Case Number: ACP-323120-25
Planning Authority Ref:
WEB2729/24

RE: ACP-323120-25 (DCC 2729/24) – Demolition of buildings/structures and construction of a 14 storey building including office use, arts centre and café, auditorium and ancillary uses. Site bound by City Quay to the north, Moss St to the west & Gloucester St South to the south, Dublin 2. The site includes 1-4 City Quay (D02 PC03), 5 City Quay and 23-25 Moss Street (D02 F854).
Applicant: Ventaway Limited.

2.0 **OPW's comments on the appeal response submission by John Spain Associates on behalf of the applicant, Ventaway Limited, on ACP-323120-25**

Fig 1. Extract from Chapter 11 of *Dublin City Development Plan 2022-2028*

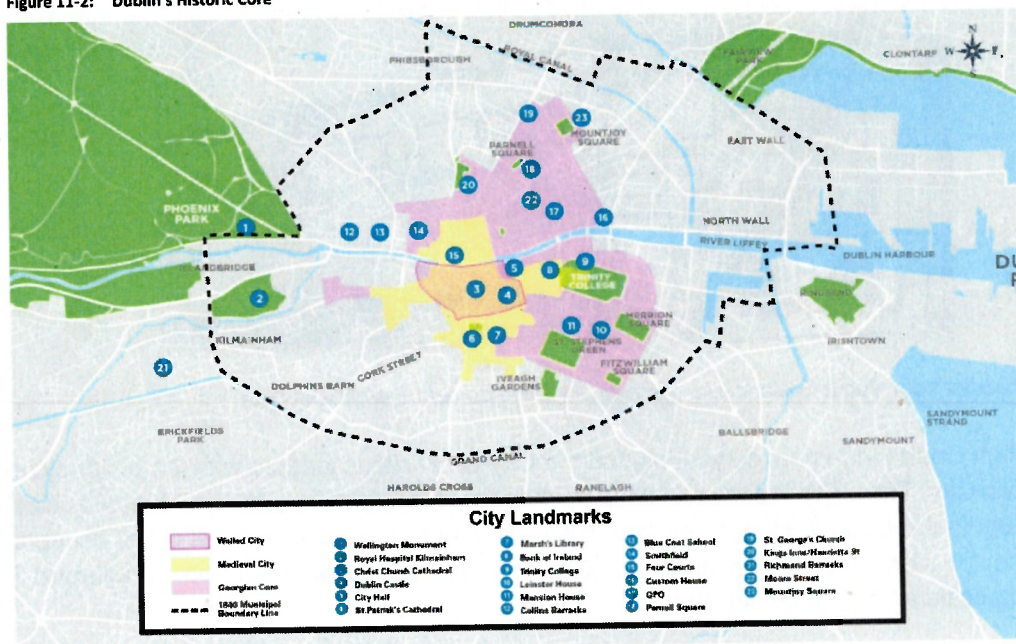
It can be seen in Fig 11-2 (Dublin's Historic Core) of the *Dublin City Development Plan 2022 – 2028* (**Fig.1**) that this part of City Quay directly borders the 'Georgian Core'. The Custom House is firmly located within this core. The OPW is aware that the definition of what

It is understood that this High Court judgement considers the historic core to be more expansive than what is indicated in the shaded areas of Figure 11.2 (Fig. 1) and to instead be more aligned to the area represented in Map L ('Historic City') of the development plan (Fig. 2).

Fig 3. Extract from Architectural Design Statement (Henry J Lyons) (pg. 4) prepared on behalf of applicant.

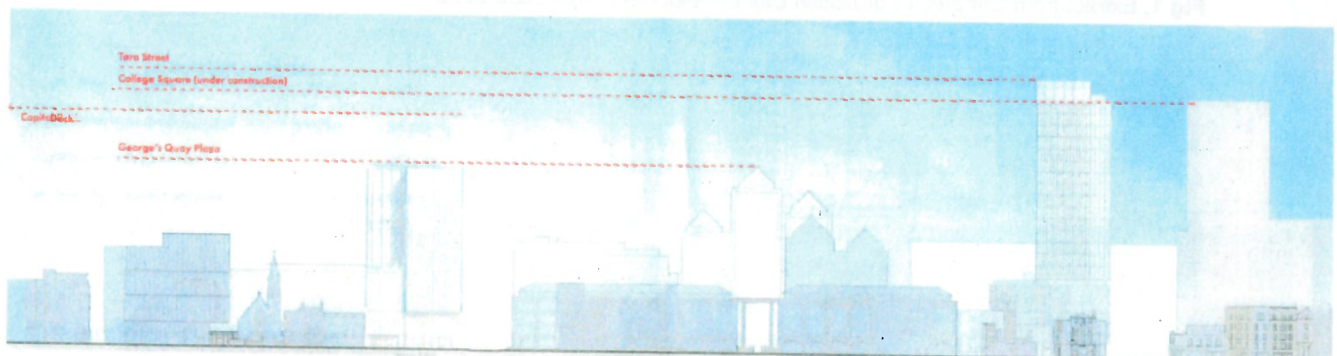
This High Court judgement concludes that the City Quay site is located within the historic core of Dublin City. The OPW is similarly of the opinion that the subject site is, by virtue of its close proximity to the Custom House, located within the historic core. As such, it is not accepted that the 14 storey design responds appropriately to its quayside context with regard to building scale and height – see [Fig. 3](#).

Having reviewed the aforementioned Architectural Design Statement prepared by Henry J Lyons on behalf of the applicant, Ventaway Limited, and the views (Figs. 4 and 5) contained within the HTLVIA, the OPW remains concerned at the proposed height and mass of the subject proposal.

It is considered that the proposed massing and height (14 storeys) of the building element located closest to the riverfront does not respect the prevailing character of the area. It is acknowledged that there are already buildings of a similar scale and height in the immediate surrounds – both existing and under construction – however, these are set back in the urban block and so their visual impact is not as severe.
